Jones Gillam Renz Architects

The Residence at Green Meadow – JGR Proj 24-3395

ADDENDUM NO. 1

sheet
C-12
Civil
LANDSCAPE PLAN
permit
30 OCTOBER 2024

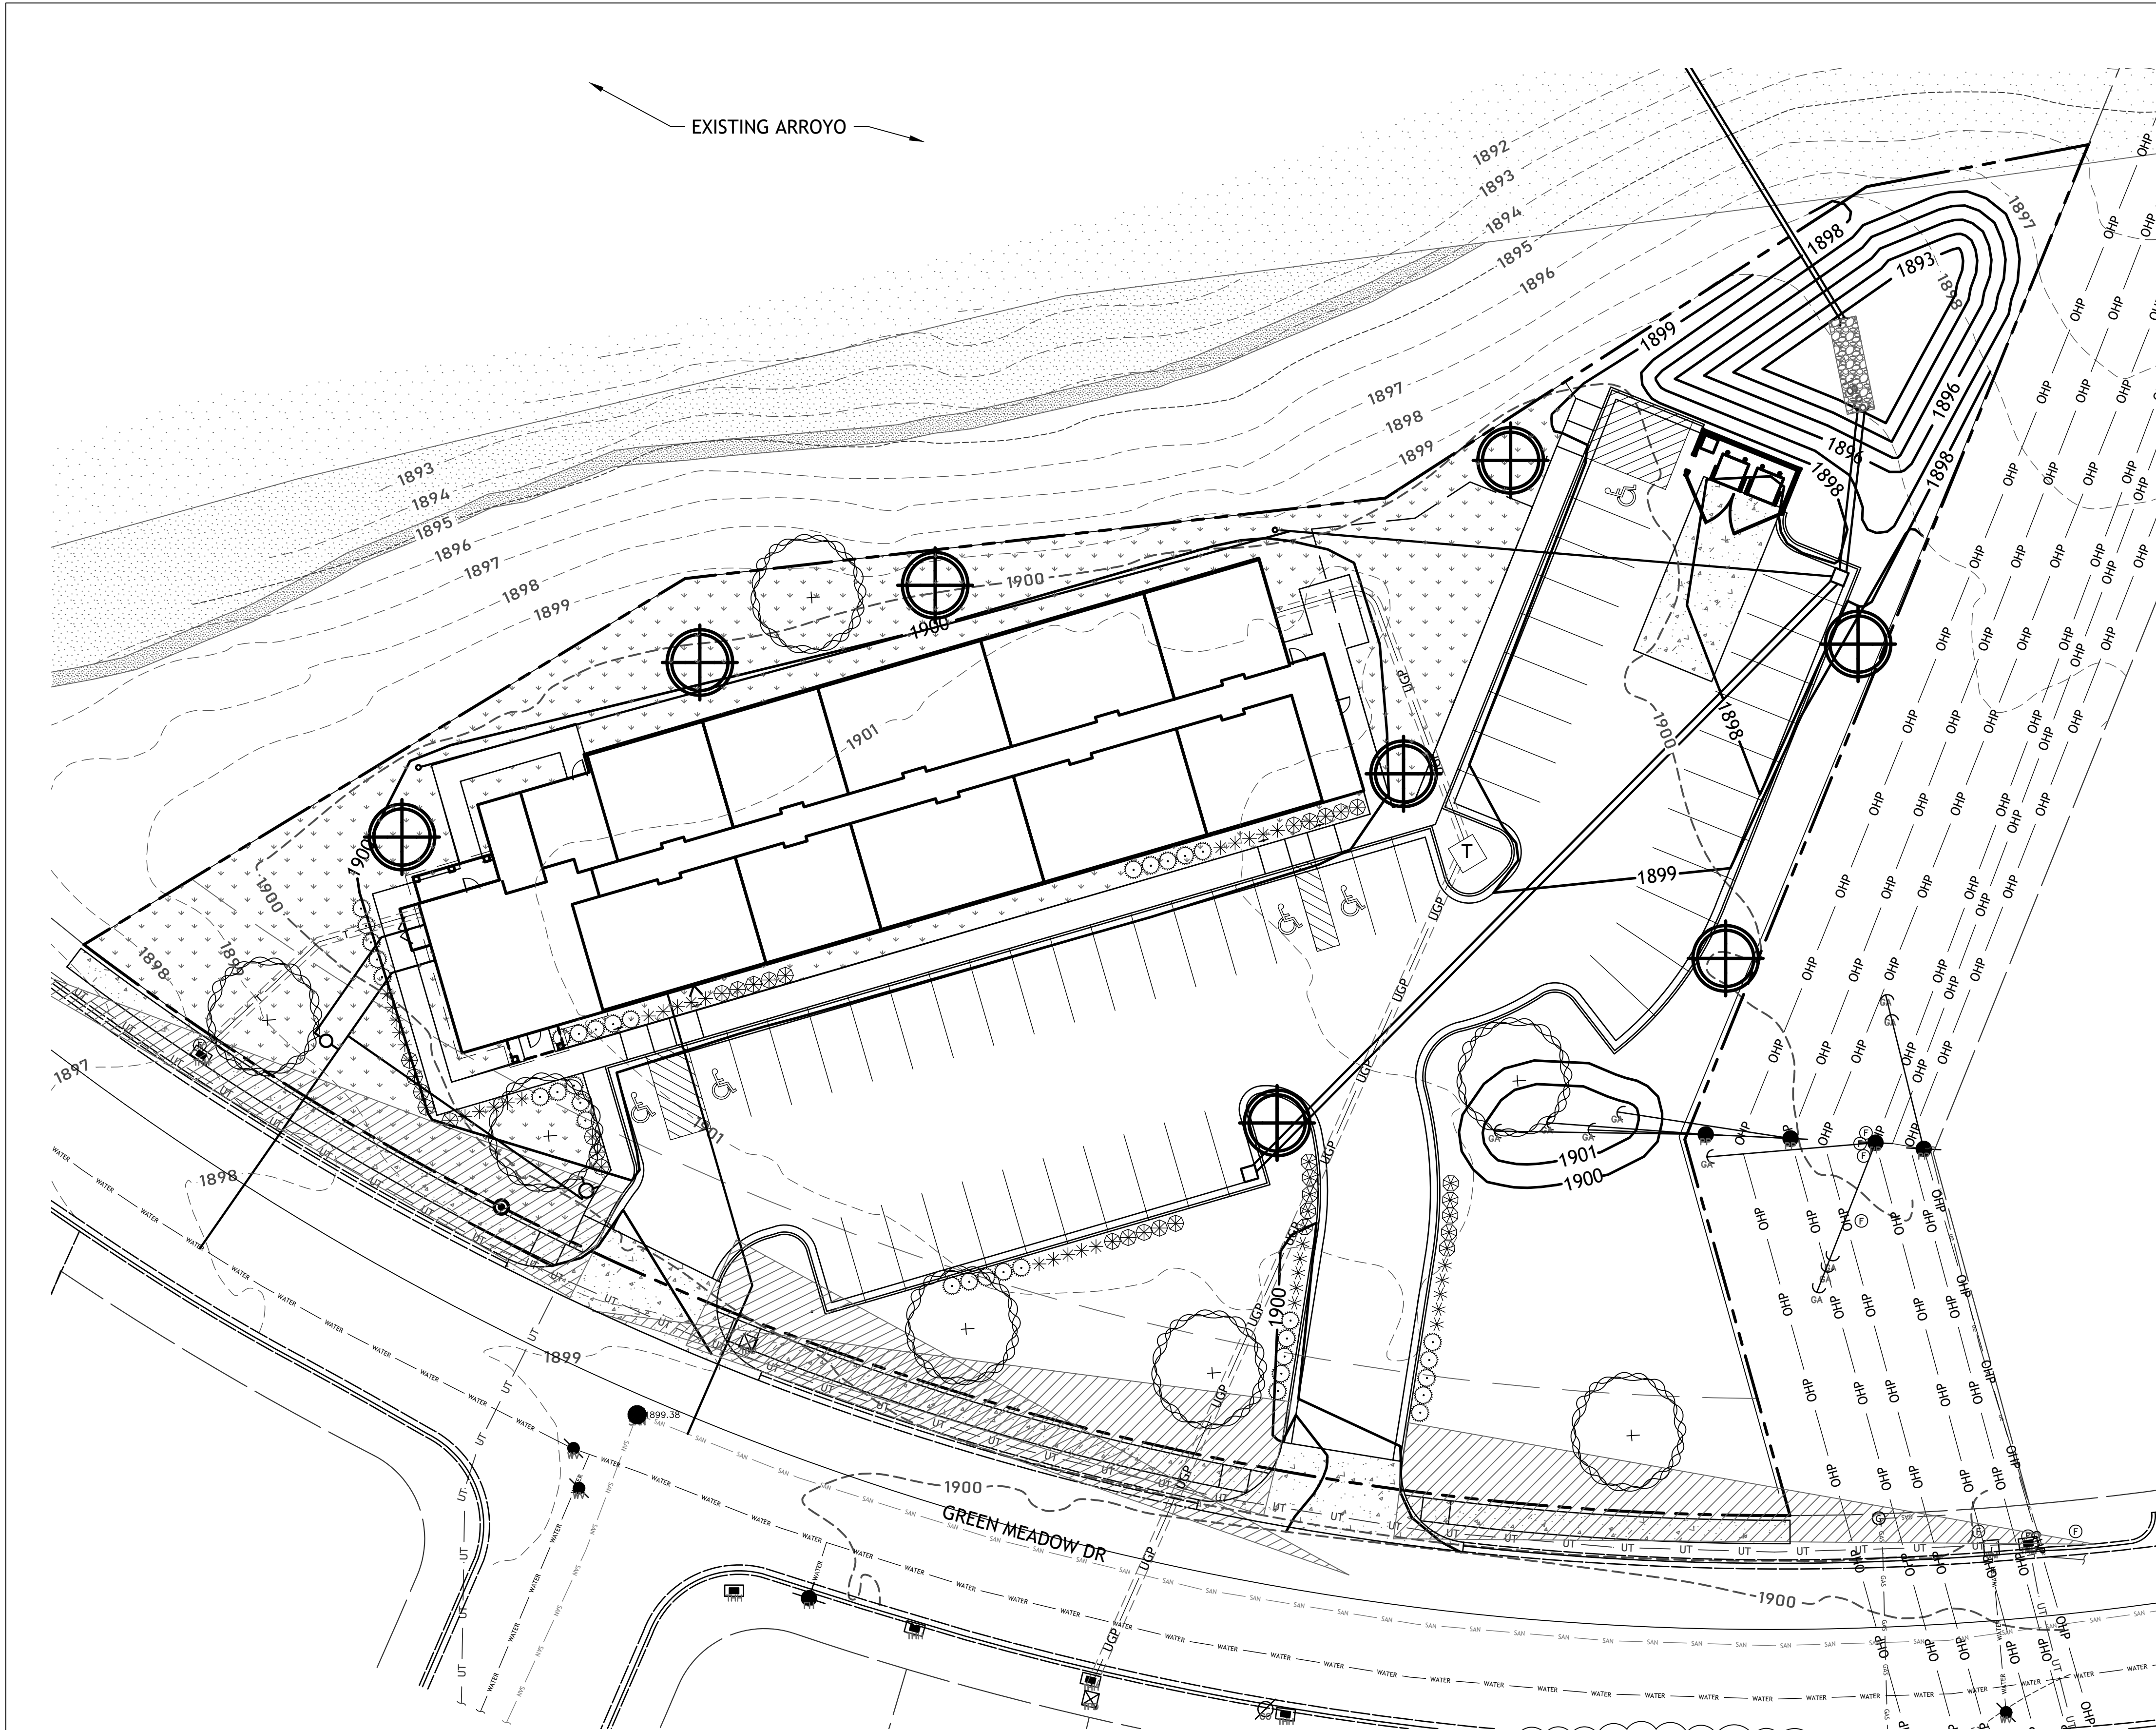
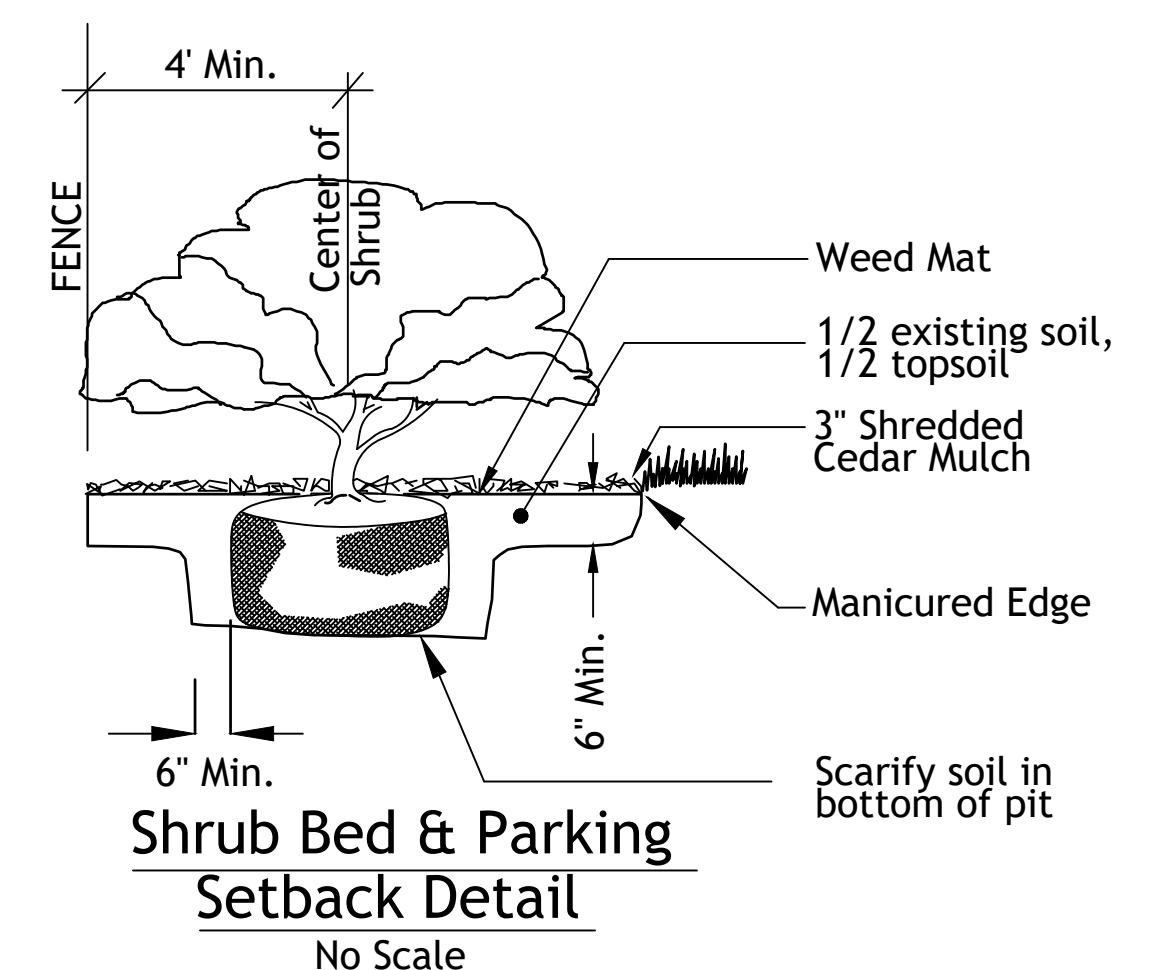
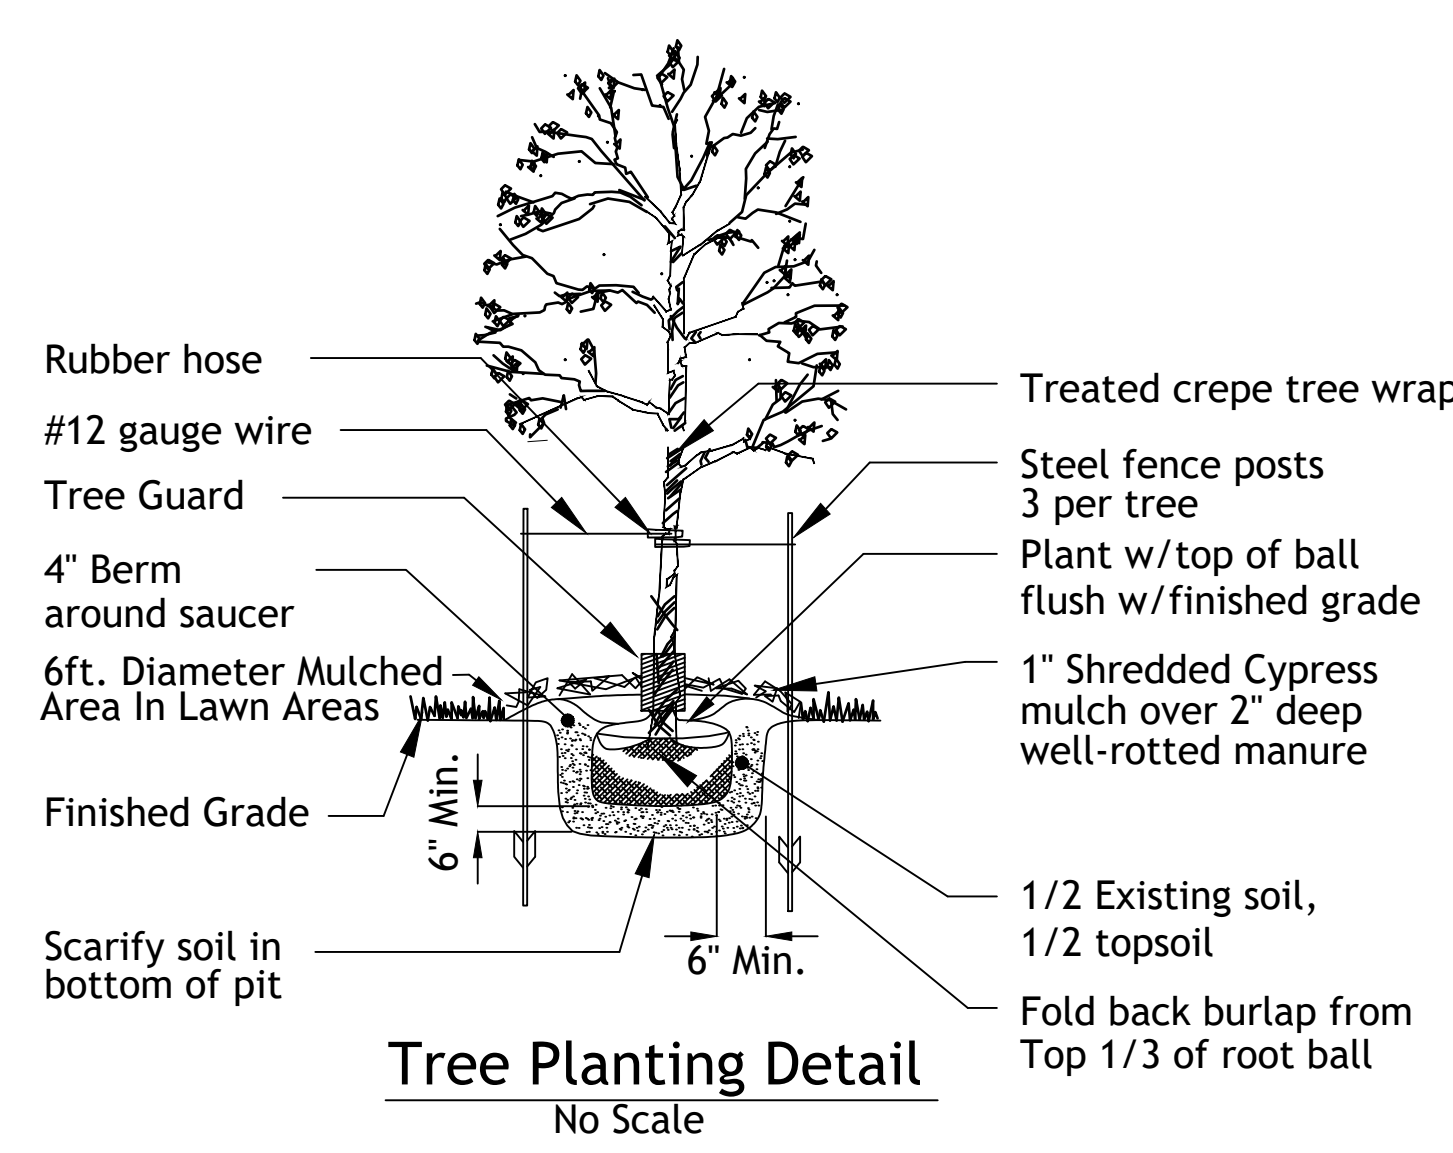
1. Sheet C-3 – Two of the four Accessible Parking spaces near the front entry have been relocated closer to the rear entry of the building.
2. Sheet C-12 – Sodded vs. seeded area has been identified and notes have been added that pertain to the seeding/sodding of the site.

AREA TO BE SODDED WITH TURF-TYPE-TALL FESCUE SEED BLEND
ALL OTHERS TO BE SEEDED

A3.1

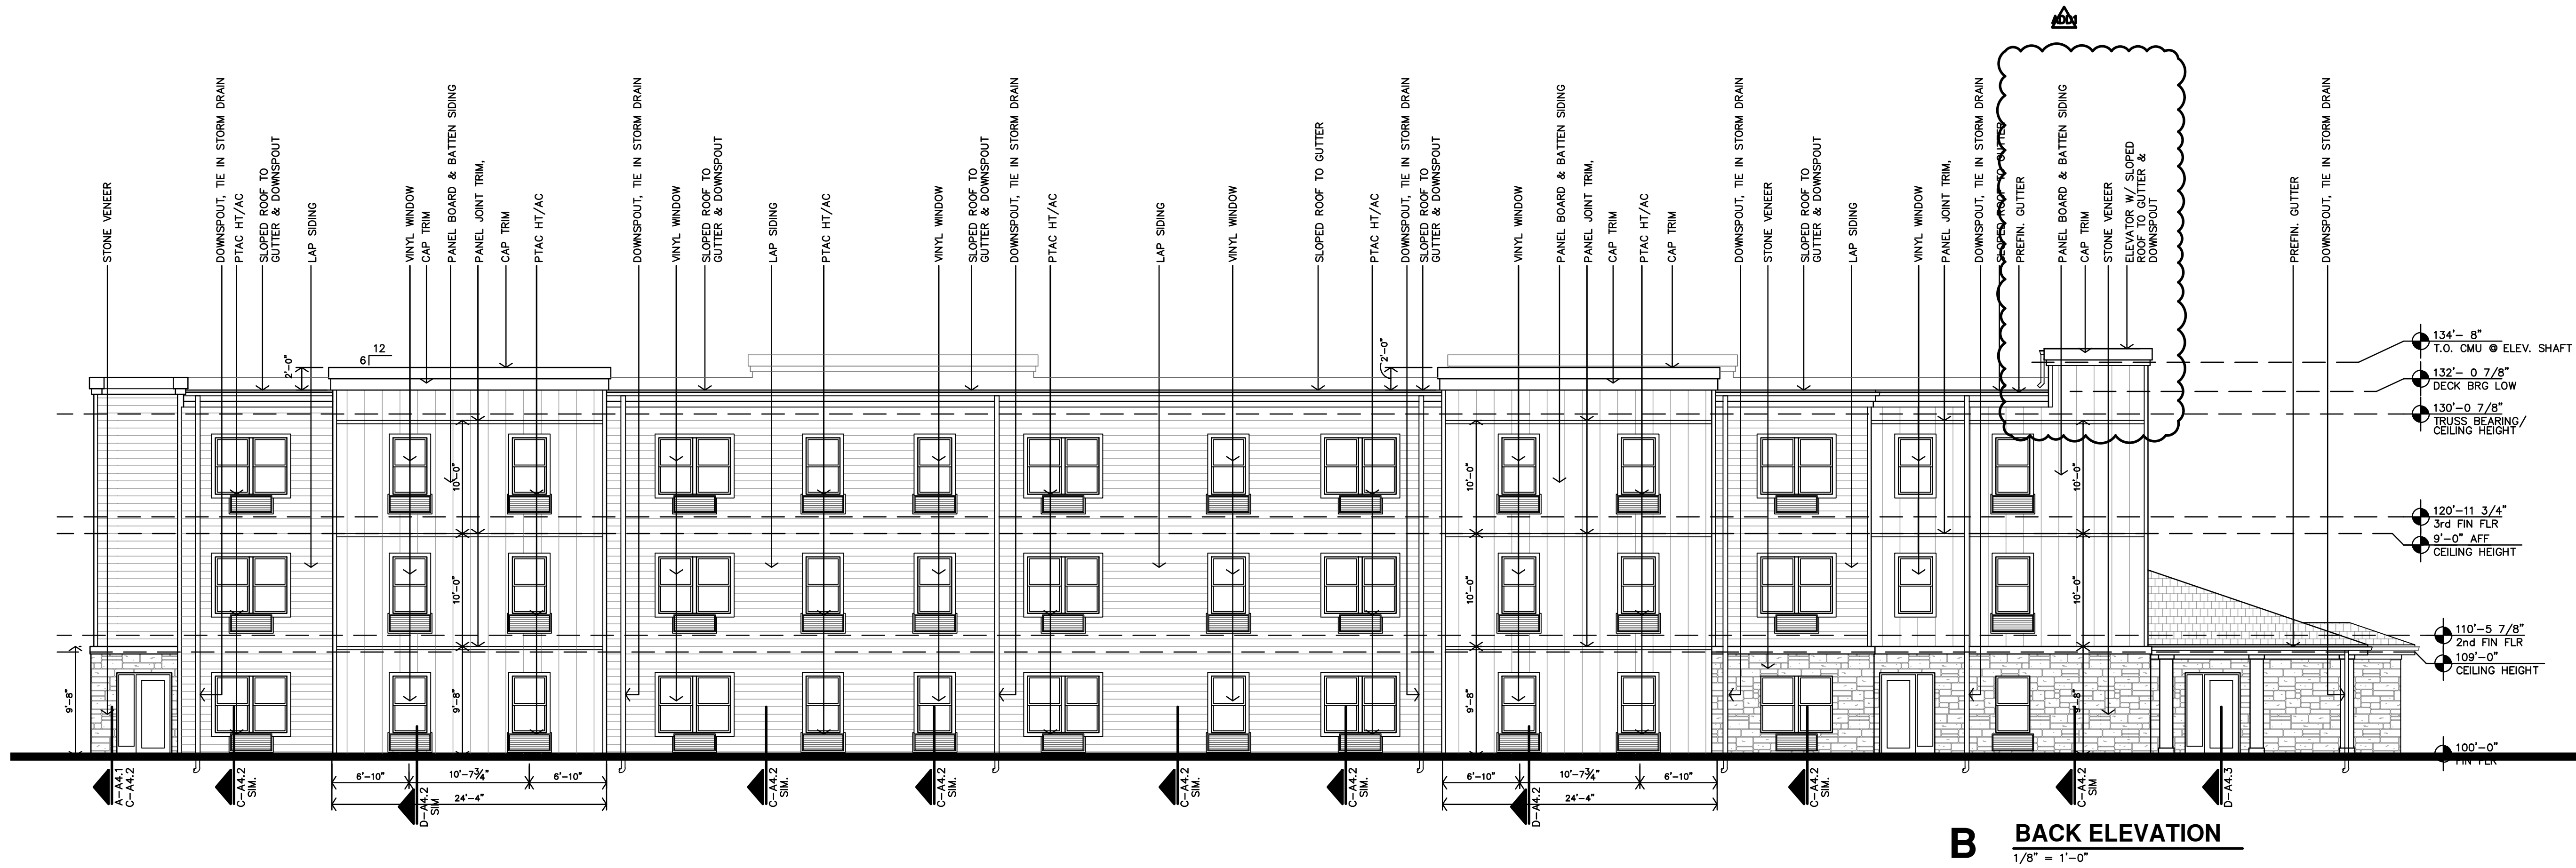
1. Sheet A3.1 – Roof/parapet at Elevator shaft adjusted to show roof sloping to drain onto low roof.
2. Sheet A3.2 – Roof/parapet at Elevator shaft adjusted to show roof sloping to drain onto low roof.
3. Sheet A5.1 – Roof slope changed to slope/drain to low roof vs. front of building. Gutter & downspout moved to opposite wall.
4. Sheet A6.2 – Roof slope changed to slope/drain to low roof vs. front of building. Gutter & downspout moved to opposite wall.
